City of Portland, Maine - Building or Use Permit Application

RE: 77 Tide Mill Road Building Permit Application Issues

Below are answers to issues you enumerated in your October 10, 2002, letter to me seeking additional information for the proposed house at 77 Tide Mill Road:

FIGURE R1003.1
FIREPLACE AND CHIMNEY DETAILS

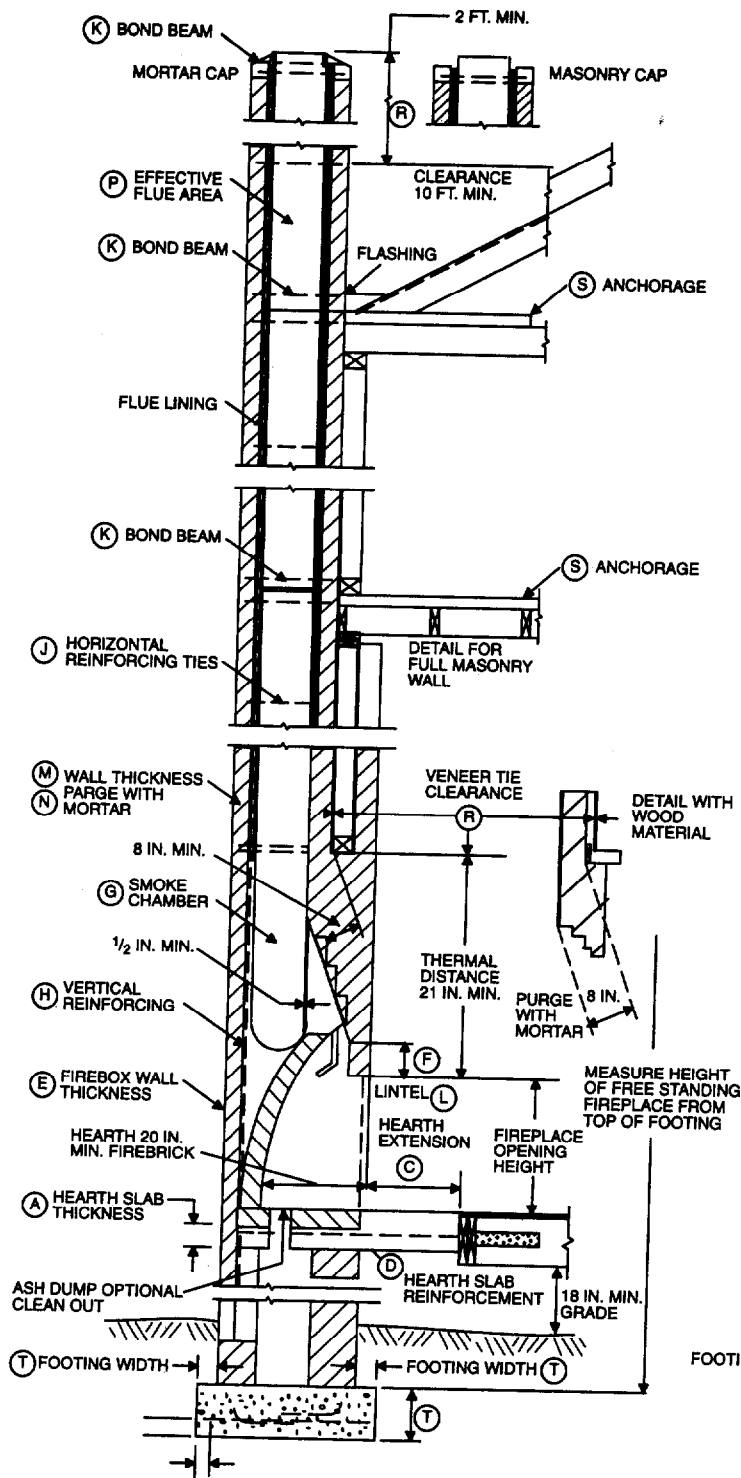
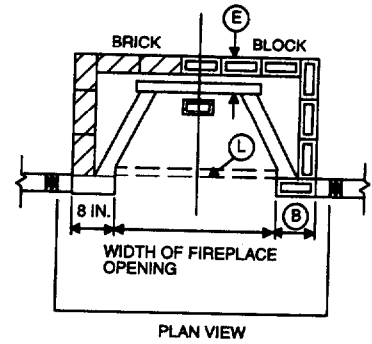
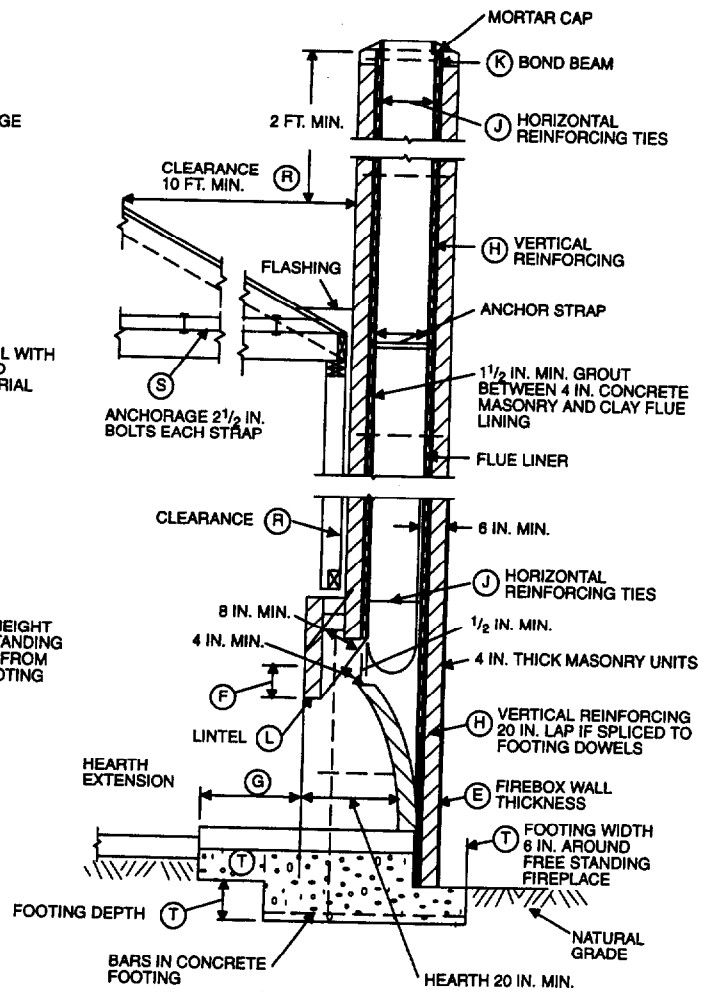
- 12) Will there be access to the enclosed space above the attic?
- 13) is the attic proposed for living or sleeping space?
- 14) Chimney plans, attached is the code checklist

12. Access to enclosed space above the attic: There is no enclosed space above the attic.
13. Is the attic proposed living space: No, currently storage space only.
14. Chimney plans: See attached completed chimney plan code checklist.
15. Structural headers not shown: 2" X 8" solid, except over garage doors which will be laminated LVLs, size TBD by engineer on site.
16. Type of Heat: Oil fired FHW boiler.
17. Hand rail/Guard rail detail: 2" X 2" balusters per city code. Second floor staircase will be open for a minimum of 6'. Railing shall continue along wall. Basement stairs will have enclosed risers and walls in addition to a railing.
18. Smoke detectors, type & location: Hard wired with battery backup in all bedrooms, first & second floor hall, garage and basement.
